Proposed Expansion of Marrickville Metro Shopping Centre

Preferred Project Report on Transport Aspects

November 2010

Prepared for AMP Capital Investors

Figure 6
Date: 08 November 2010

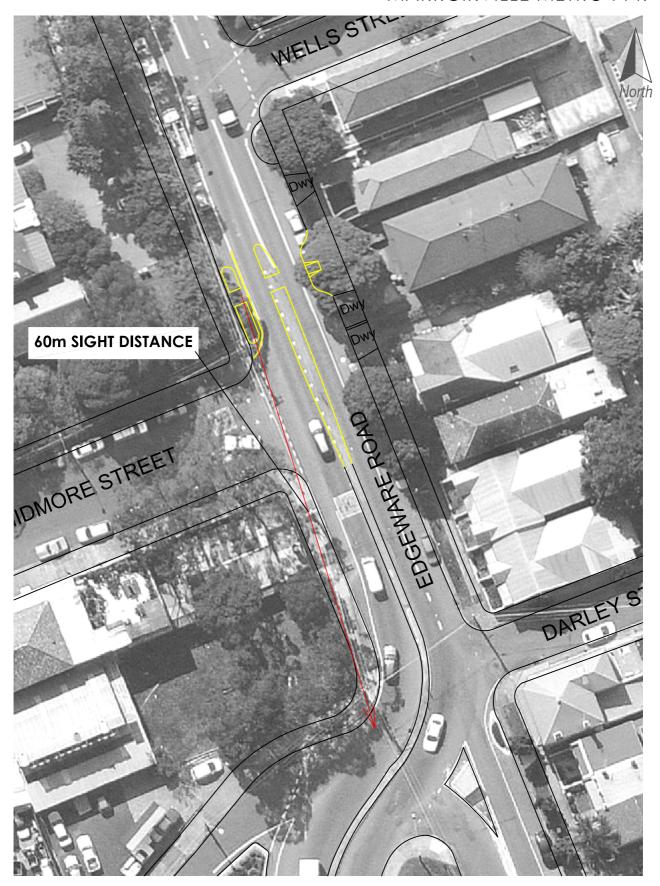
3.4.1.15	The proposed siting of a pedestrian refuge on	Ultimately this crossing would be a matter for
	Edgeware Road, south east of Smidmore Street	the Local Traffic Committee. However, since
	raises safety concerns due to its proximity to an	receiving this comment the suitability of this
	"S" Bend on Edgeware Road which limits sight	crossing point has been re-examined on a site
	distance for pedestrians and traffic.	visit. From this, Figure 6 was prepared
		which indicates that sight distances would be
		satisfactory at this location (Figure 6 is
		located with plans following this Chapter 3 of
		the report).

PROPOSED PEDESTRIAN REFUGE ON EDGEWARE RD

Figure 7

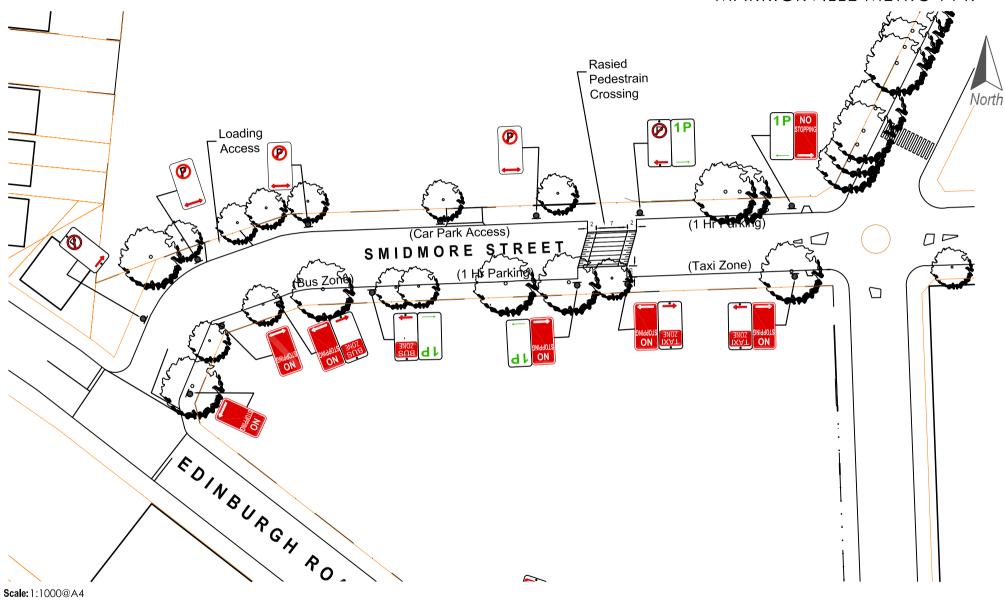
3.4.1.16	Further information is required concerning the	Attached Figure 7 indicates proposed "no
	location and extent of the proposed "Pickup /	parking" zones along Smidmore Street.
	Set down" zone. These would usually be	These can legally be used for set-down and
	located in close proximity to entrances.	pick-up activities. They would be in close
		proximity to the Smidmore Street entrances.

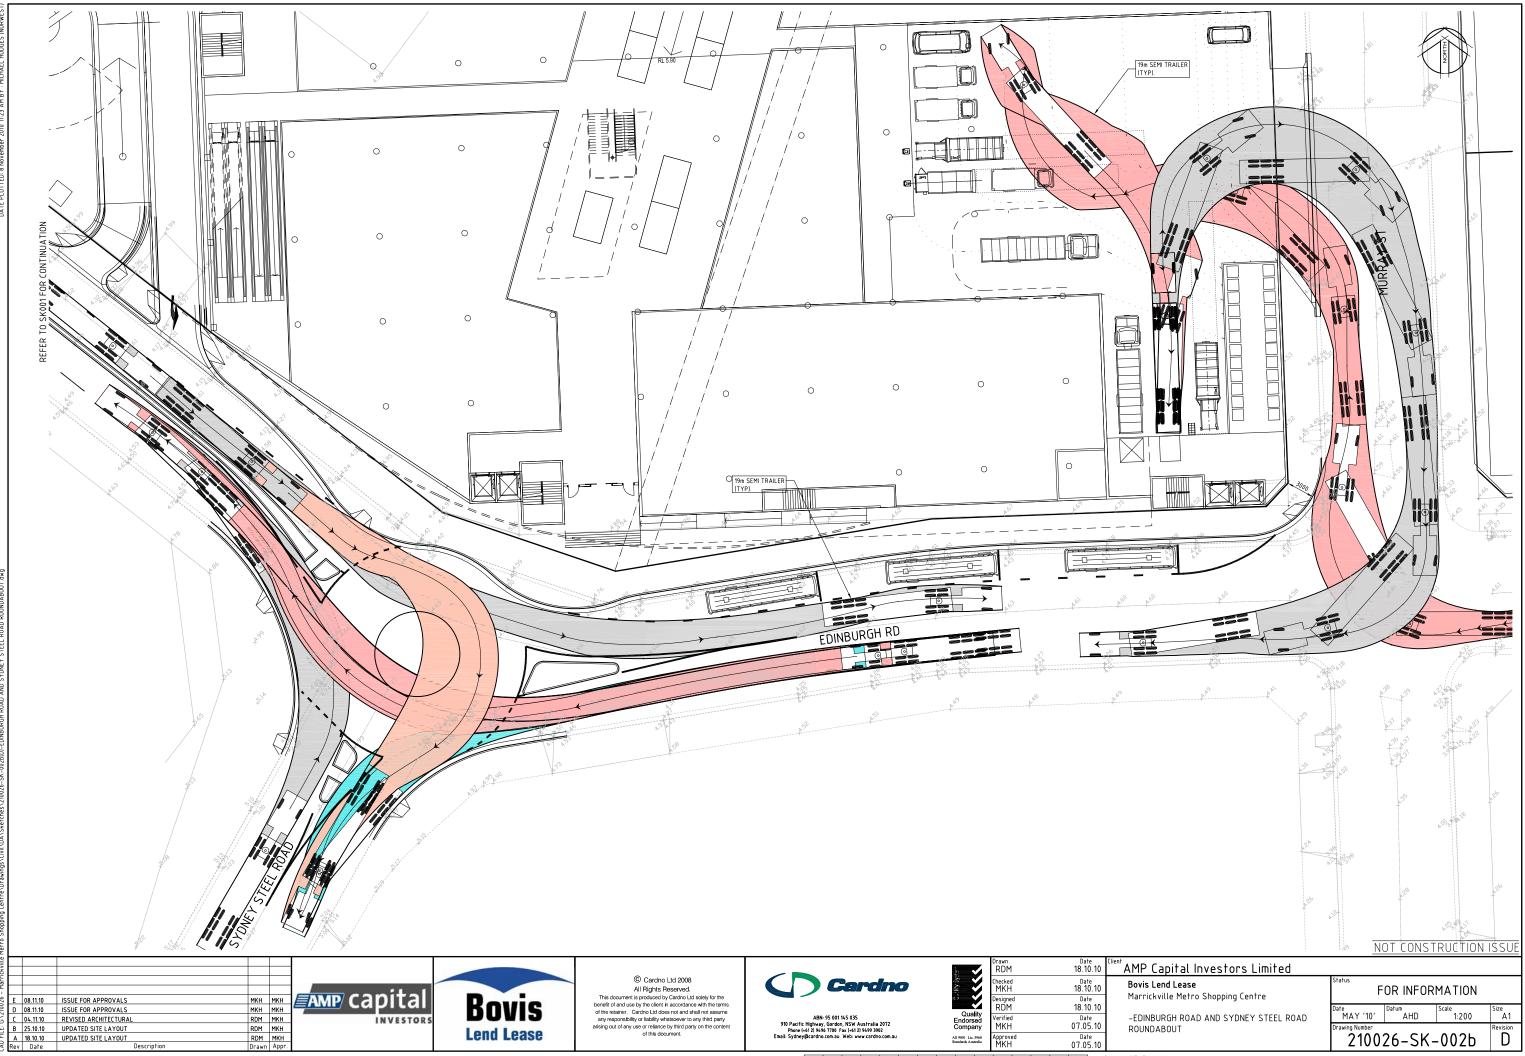
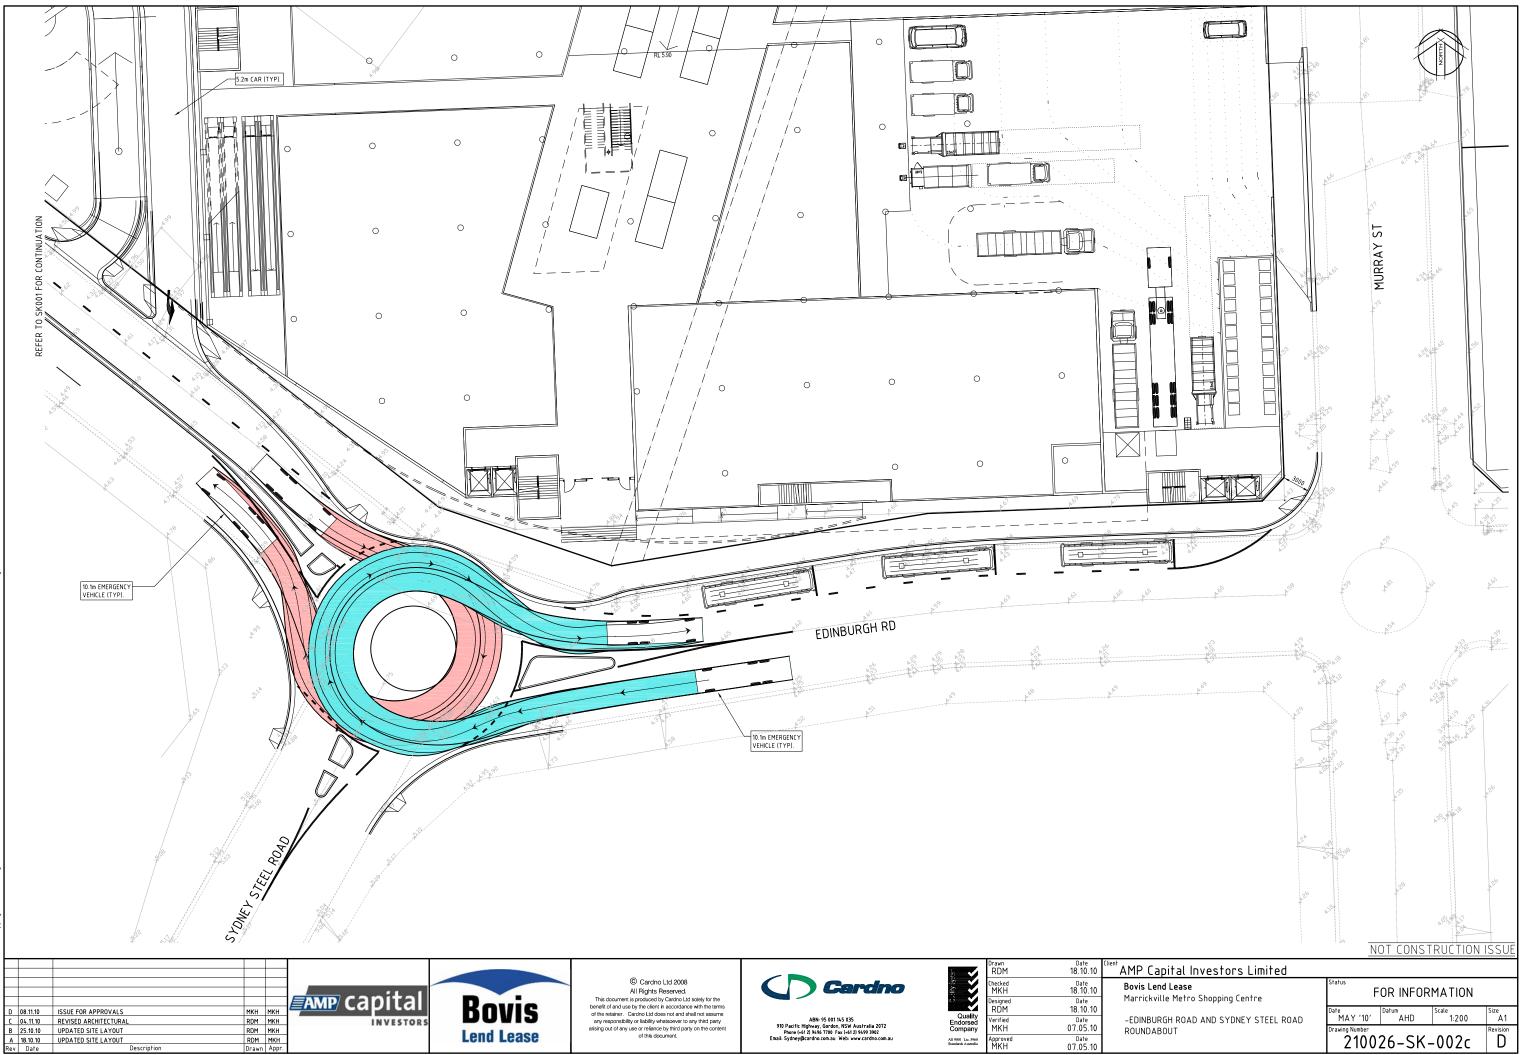
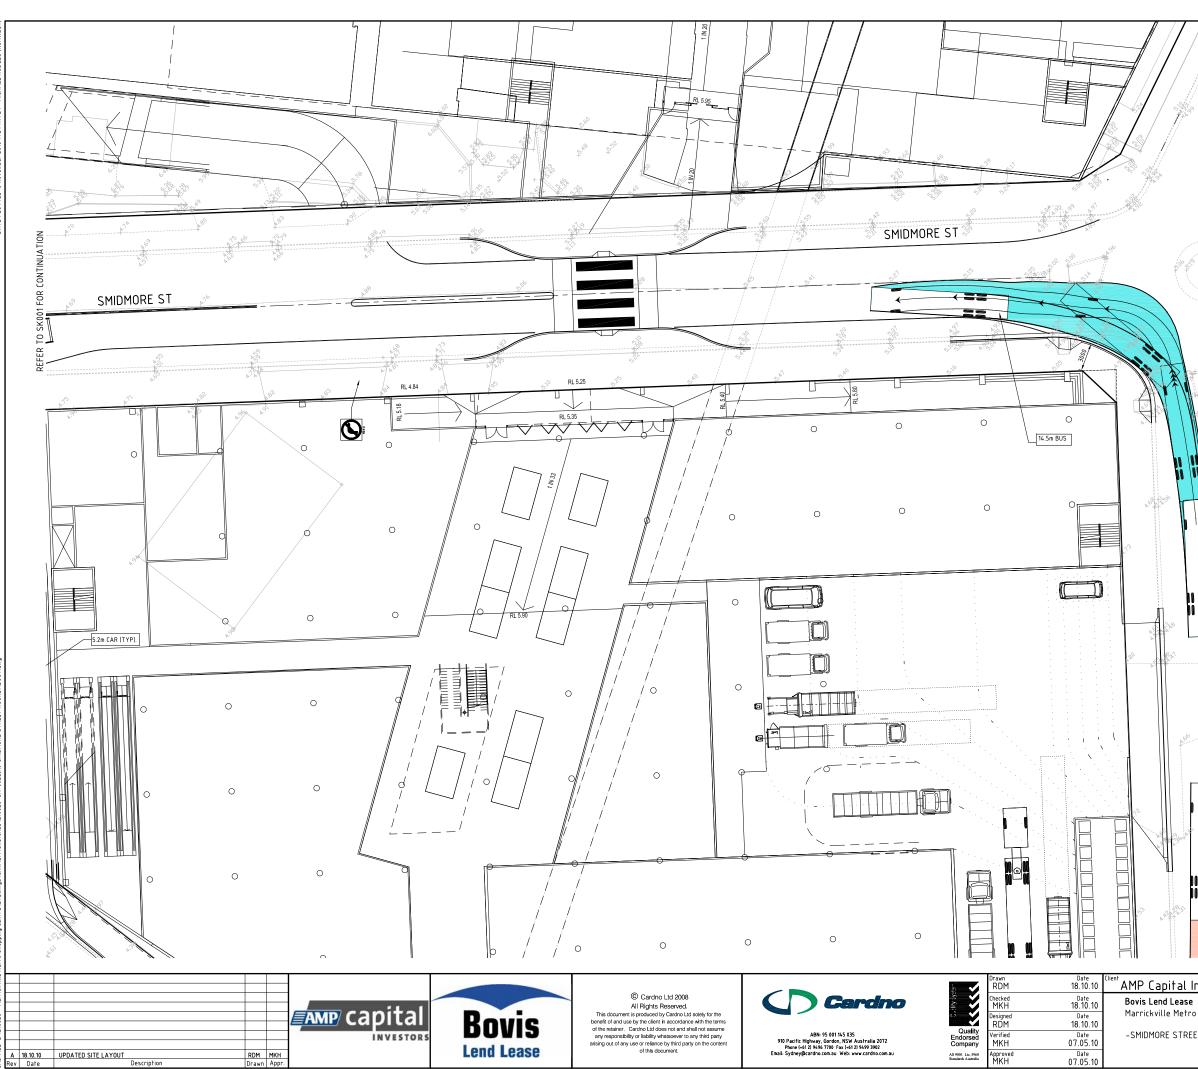
• Independent operation by two normal buses
		and one long bus; and
		• Nose to tail operation by three long buses.
3.6.2	STA requires a scale, engineering drawing that	This plan has been prepared by Cardno
	displays the proposed alterations and	Consulting Engineers.
	construction of a roundabout at the Intersection	
	of Edinburgh Road and Sydney Steel Road. This

drawing needs to include, height and dimensions	
	for the roundabout, any changes to the	
	intersection, and an auto turn path	
	demonstrating its suitability for 12.5 metre buses.

3.4.1.5	Proposed changes to bus operations (i.e. bus	The proposal no longer requires the rerouting
	stops and re routing) are dependent on	or U-turning of buses. Accordingly the
	agreement being obtained from Sydney Buses.	roundabout proposed for this intersection has
		been redesigned to overcome these concerns.
		A copy of the modified design is provided in
		Appendix F.
